Technical Service Bulletin: TSB240152

Released Date: 26-Jul-2024

New Engine Heat Shields

Figure 1, Option SH6726 With Service Covers.

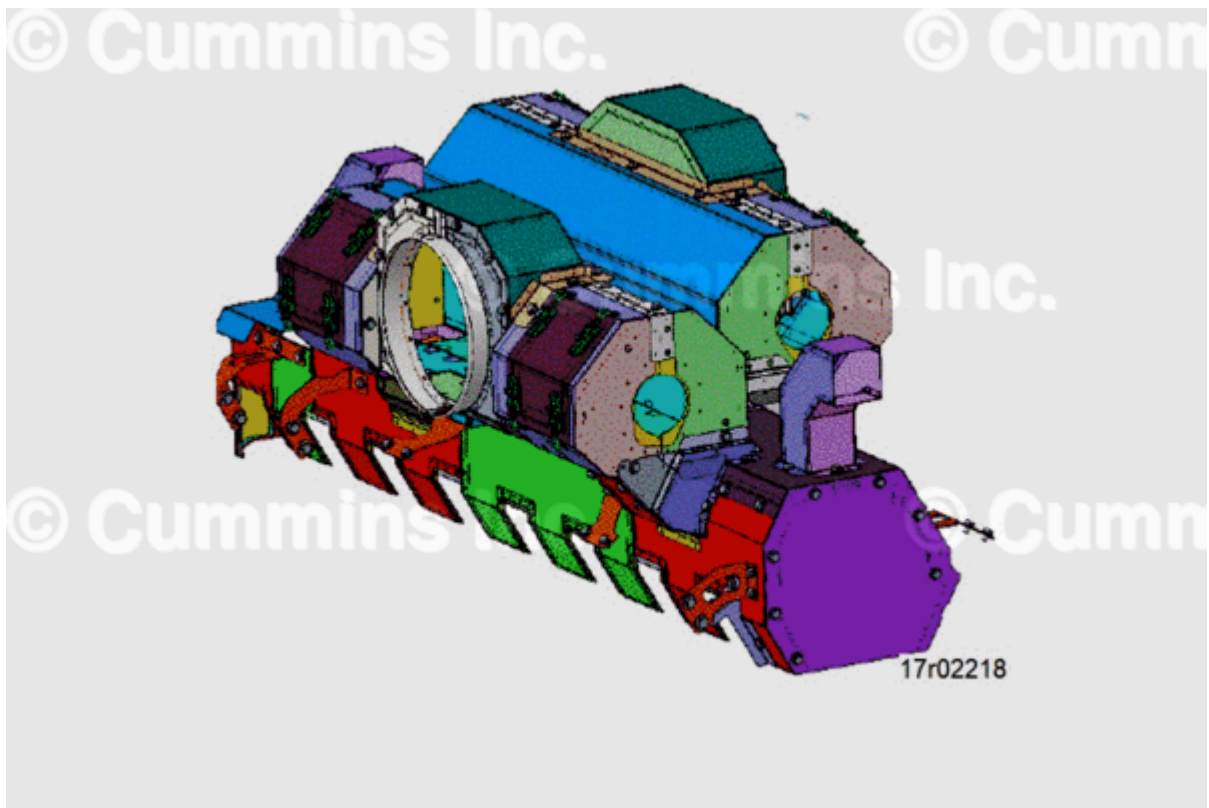
A new heat shield design has been released for the single stage variant, which introduces an improved clearance for other components such as injector fuel supply line, low temperature aftercooling pipe, and turbocharger oil drain.

- This change has come out of product improvement where some clearance issues were seen to cause malfunctions of different components (injector fuel supply line, low temperature aftercooling pipe, and turbocharger oil drain). The design was improved to reduce future malfunctions.
- Because of the complexity of the change, see the below graphics to understand the change in geometry for each option.

Figure 5, New Parts Being Released.

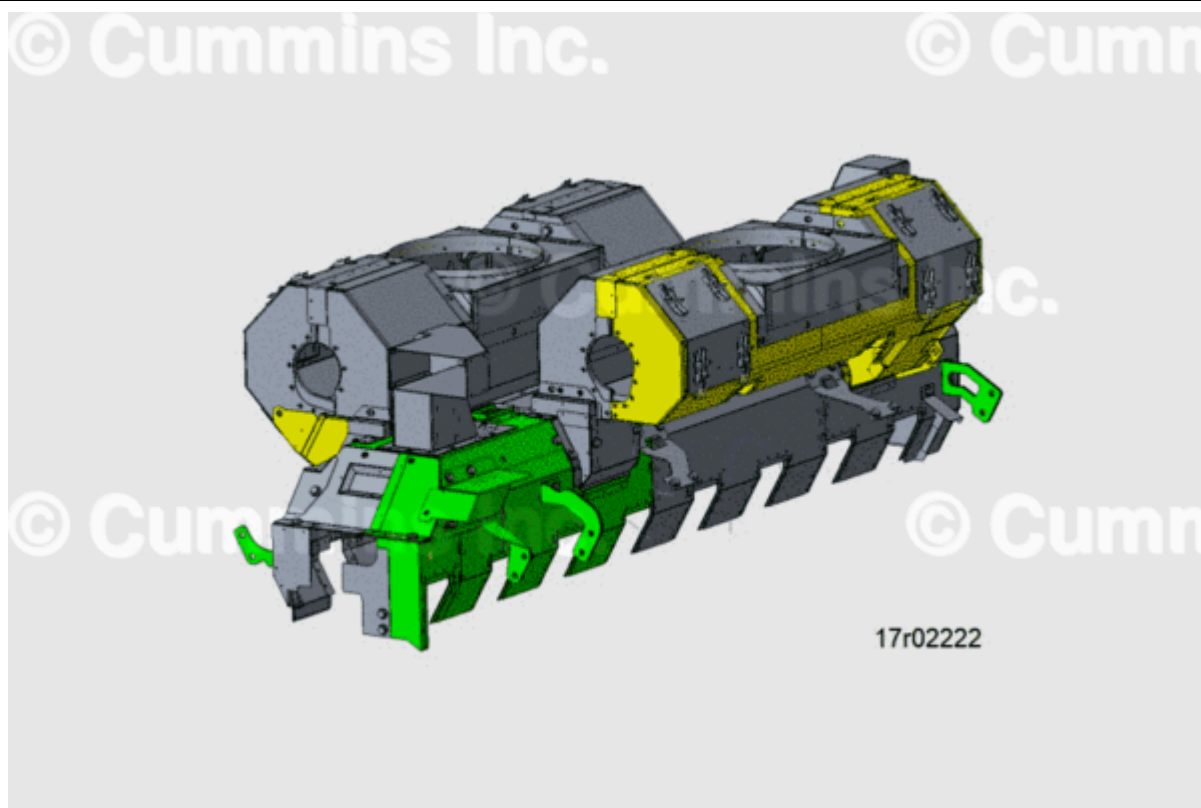
The parts highlighted in green and yellow in Figure 5 are the new parts and are contained within all option graphics listed above.
